Re: Lot 1 (22 Oakwood Drive), Beacon Falls, Connecticut

I have reviewed the Department of Health comment letter and would like to respond by providing the missing information that they are requesting. This project has received specific approval from the local health dept. for phase 1, and the test hole data has been approved for the other phases. A Stormwater pollution control plan has also been prepared for the Stormwater general permit for construction activities per the DEEP requirements.

The Connecticut Department of Public Health (DPH) Comments

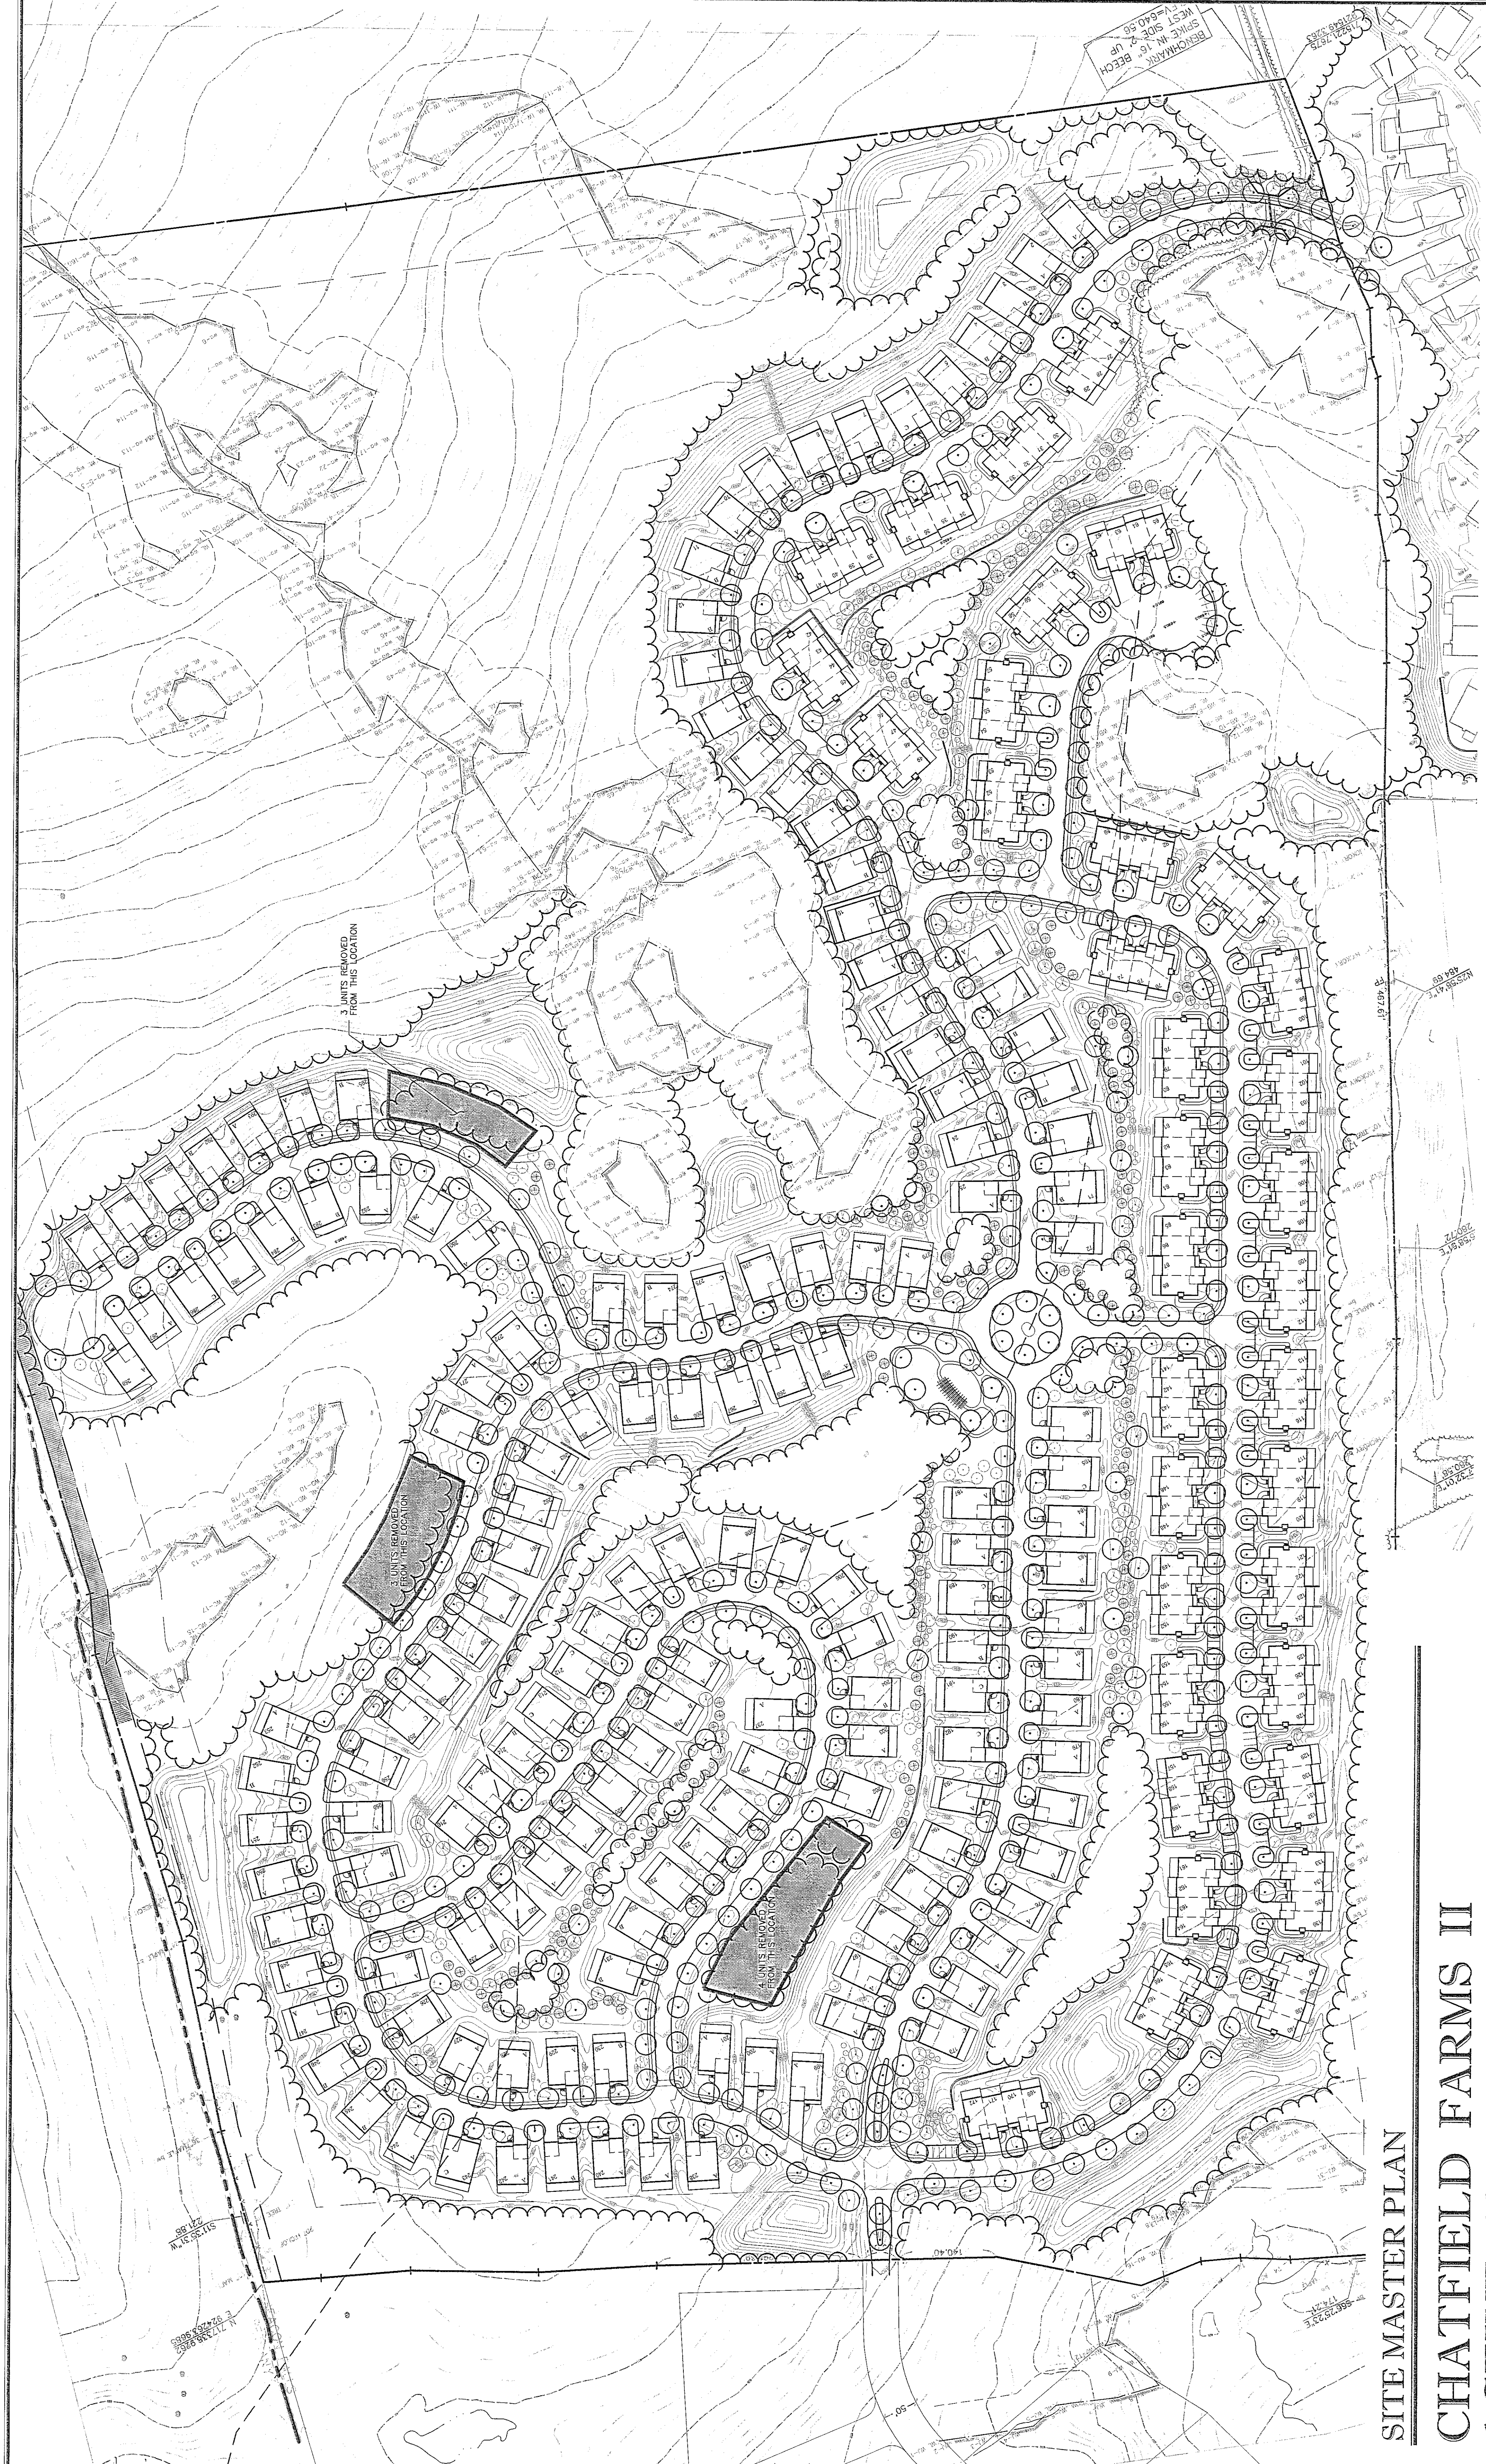
7. The stormwater system should be designed, constructed and maintained to direct runoff northwest and away from the Watershed boundary and in consistency with the Connecticut Stormwater Manual⁴. Pre-construction stormwater analysis should assess the long-term efficacy of the proposed stormwater infrastructure and controls, including the two detention ponds, and evaluate how those controls will function during phased construction and prior to full buildout.

R The Majority of the site is constructed and directs water to the north west watershed, only a small portion of the development is within the south eastern water shed, (as shown in the figure below) both water sheds have a treatment train and storm water controls to insure good water quality and promote filtration and infiltration of the storm water. The southerly water shed has a dedicated 40.27 acre open space buffer and wetland areas before leaving the site to the south east. Also refer to Appendix B the Phase 1 Environmental report section 3.2 &3.3.

Previous Proposed Site Plans Chapfield II

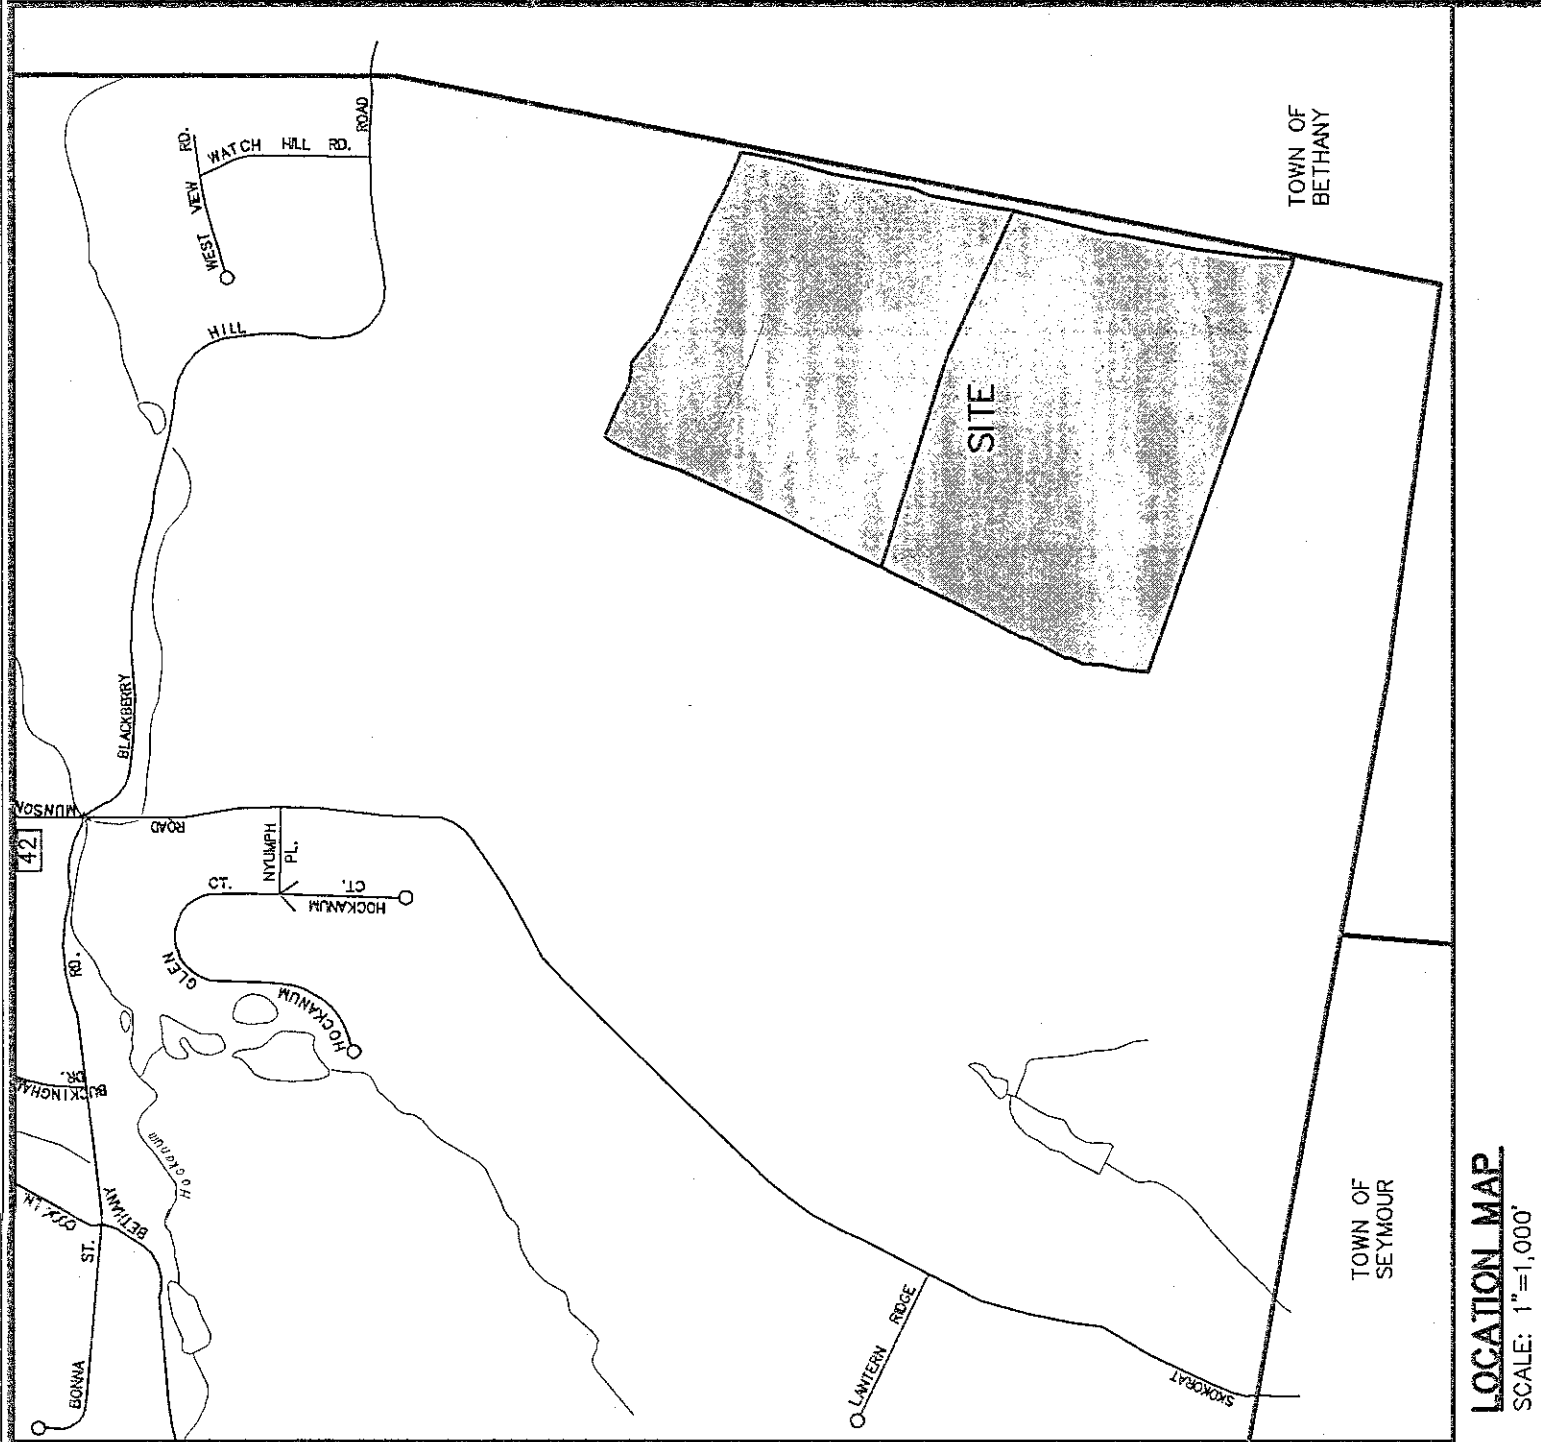
1. Reduce the amount of land converted from forest, such as through fewer and/or larger building lots with mandatory forest buffers separating each lot;

- R. The development is a compact or cluster development of 94 single-family homes on 135 acres, with a development impervious area of only 13.89 acres or 10.3%. All the proposed houses are located on Lot 1, which is 59.46 acres, and the remaining Lot 2 will have 76.35 acres, of which 40.27 acres are being deeded as public space. The project, as proposed, is a much less impactful alternative to the original proposal of 295 townhouses and single-family units known as Chatfield Farms II (see Chapfield-II.pdf), which had a proposed impervious area of 25.2 acres or 18.6%.**
